International Expert Review of SR-Can: Engineered Barrier Issues

External review contribution in support of SKI's and SSI's review of SR-Can

March 2008

Figure 3: Illustration of SKB's revised concept for backfilling of waste deposition tunnels. From Gunnarsson (2007).

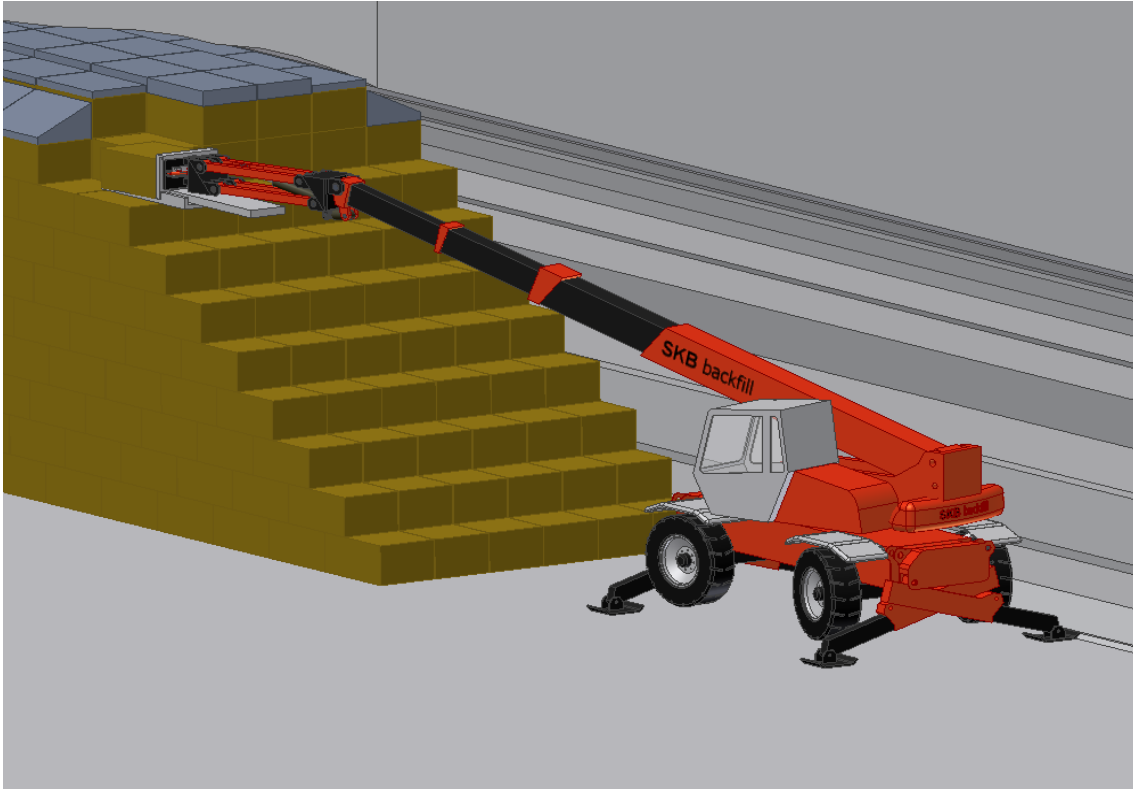
The review group has two types of observations on SKB's revised backfilling concept relating first to the process used by SKB to identify the revised backfilling concept, and second to details of the preferred backfilling concept and its potential implications.

Second, with regard to the details of the preferred backfilling concept (pre-formed clay blocks and bentonite pellets), the review group notes that the concept was developed for use with drill and blast tunnel excavation techniques (SKB, 2002) and that it may have to be redesigned (e.g. in terms of block geometry, stacking pattern and installation equipment) if a decision was made to use a tunnel boring machine. The review group also notes that SKB has not yet defined or proposed in detail how it would go about backfilling other repository cavities such as shafts (see SKB, 2006f, page 93).

The topics of demonstrating the feasibility of EBS fabrication and emplacement, and erosion of backfill are addressed in more detail below, but the review group considers that it will be essential for SKB to demonstrate that the backfill can be emplaced successfully at the rates of emplacement that will be required in the repository and given realistic groundwater inflow rates through fractures. One concern is that piping of backfill by inflowing groundwaters during the operational period could slow backfill emplacement operations and possibly result in a backfill with a final density lower than required.

Figure 1 Saturation time of Friedland backfill as a function of fracture spacing and transmissivity

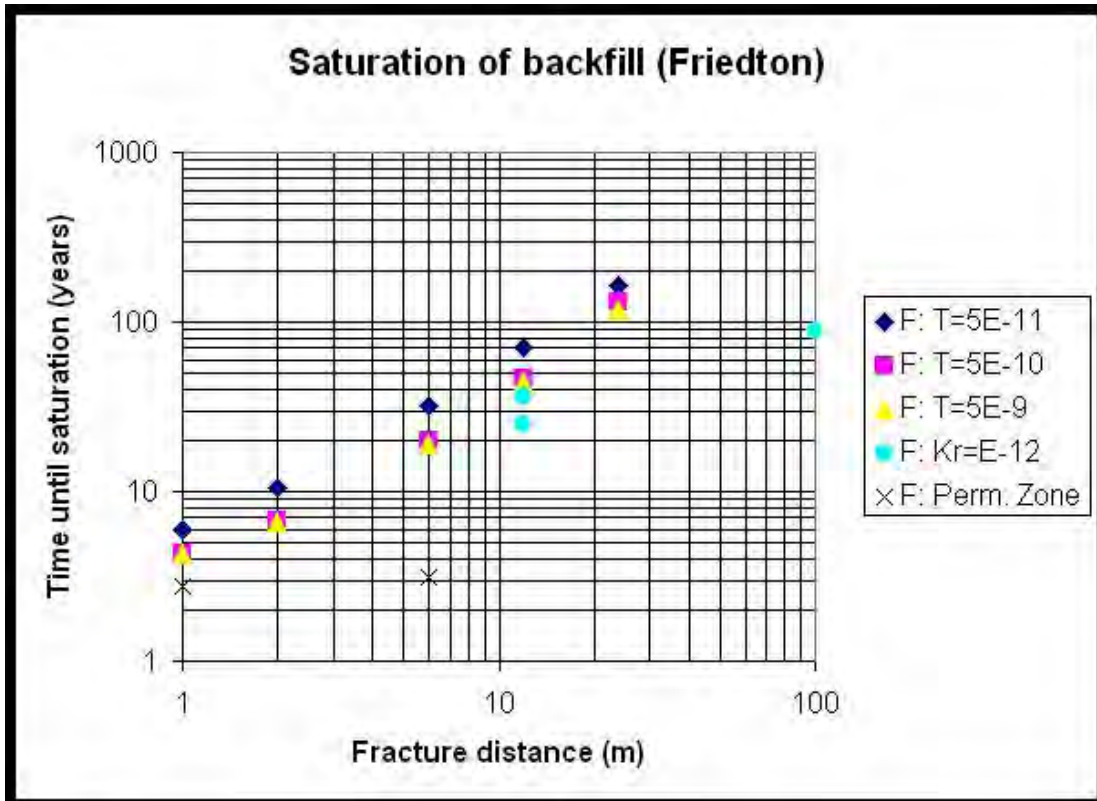
h) How do expected rates of backfill re-saturation relate to fractures in the host rock, how variable might backfill re-saturation be? What factors, including potentially adverse impacts, determine the amount of variation in re-saturation that can be accommodated and how much variation can be accommodated?

This is presented in SR-Can and in more detail in /Börgesson et al SKB TR-06-14/. Figure 1 shows the saturation time for the Friedland backfill as a function of fracture spacing and transmissivity. The saturation time will most likely vary from a few years to a few hundred years in different parts of the repository. Backfill saturation time is not seen as a critical issue for repository performance.

Figure 2 Coffee table experiments, where bentonite is expanding out into a slowly flowing water in a artificial fracture between two plexiglass plates

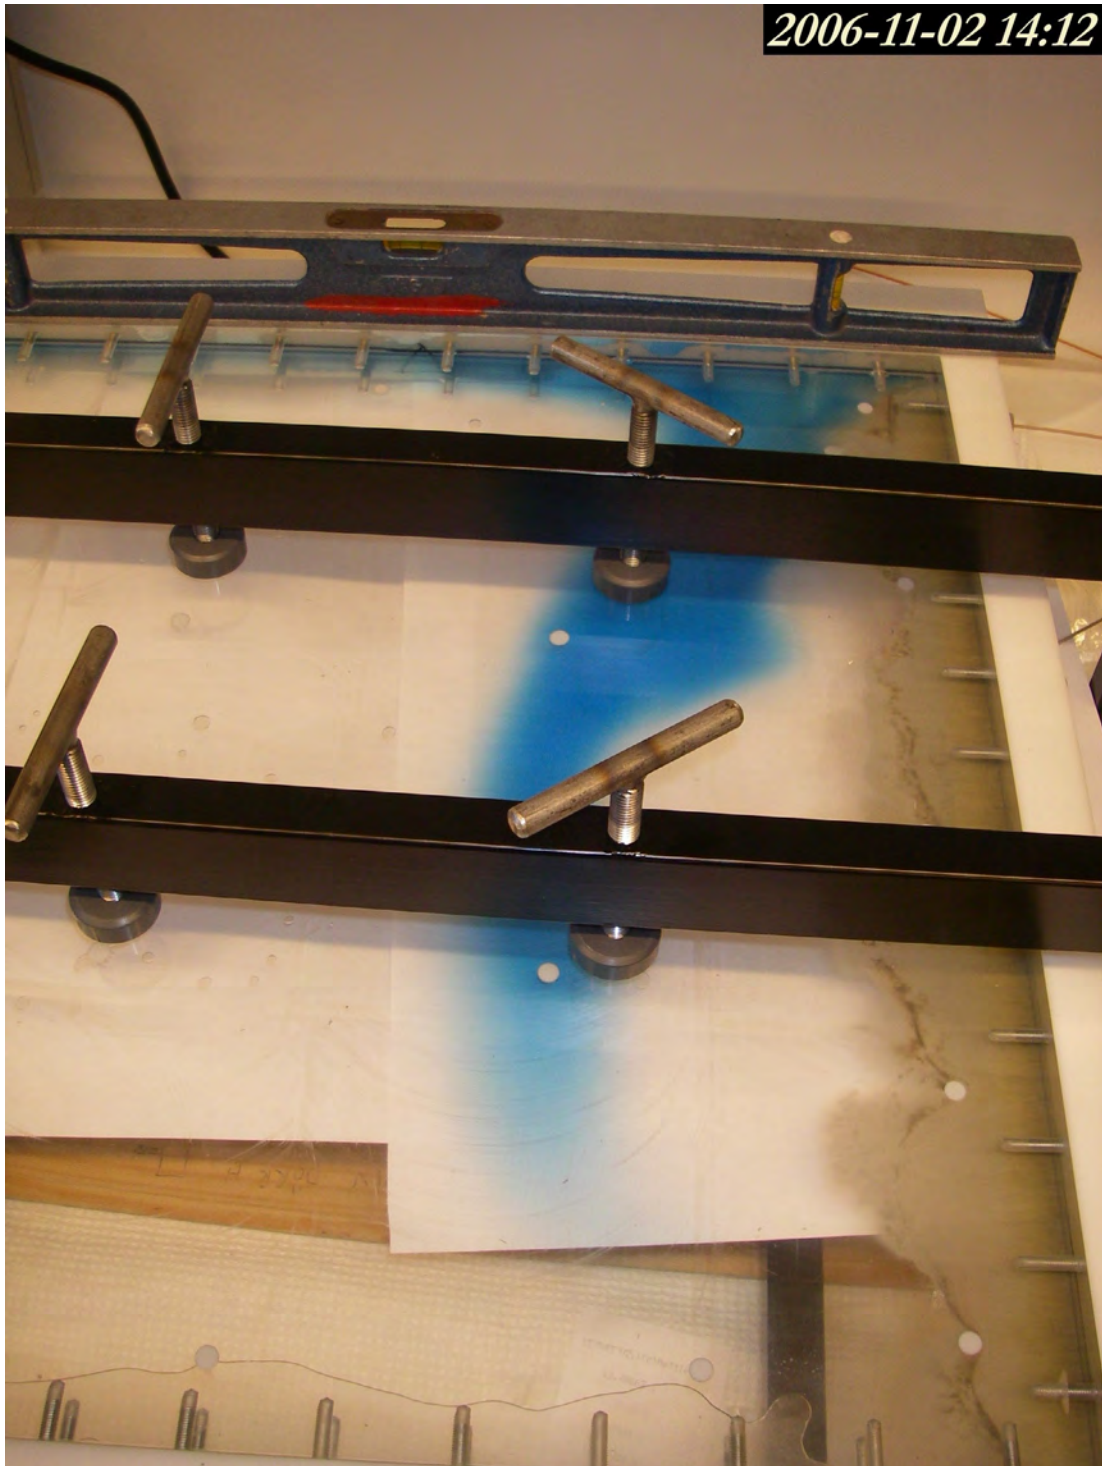
- d) In detail, what further experiments are planned on piping and erosion?**

The piping process is studied in medium-large scale experiments in the KBS-3H and Baclo projects.

The colloid formation process is studied within the Bentonite Erosion project. This project includes an extensive range of experiments, among them the coffee table type (Figure 2).

Figure 1. The case in Figure 10-42 of TR-06-09 extended to 10^9 years.

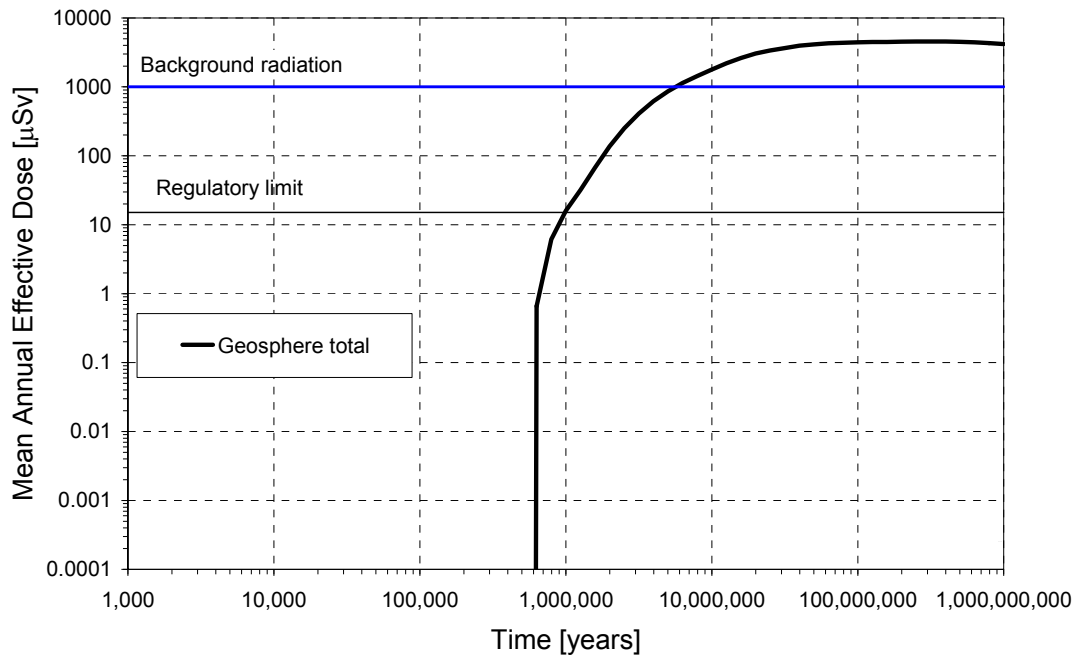
g) What is the peak dose rate for a given scenario/ variant case?

This has been calculated for the Forsmark advection/corrosion base case, i.e. the case presented in Figure 10-42 has been extended, as a response to this question, see the below figure. The peak calculated dose is around 4 mSv, i.e. about four times the background radiation. For the extended calculation, it is simply assumed that canister corrosion and fuel alteration continues at the same rates as in the one million year timeframe and that the transport properties of the host rock are not altered. Probabilistic calculation, 10,000 realisations, analytical model.
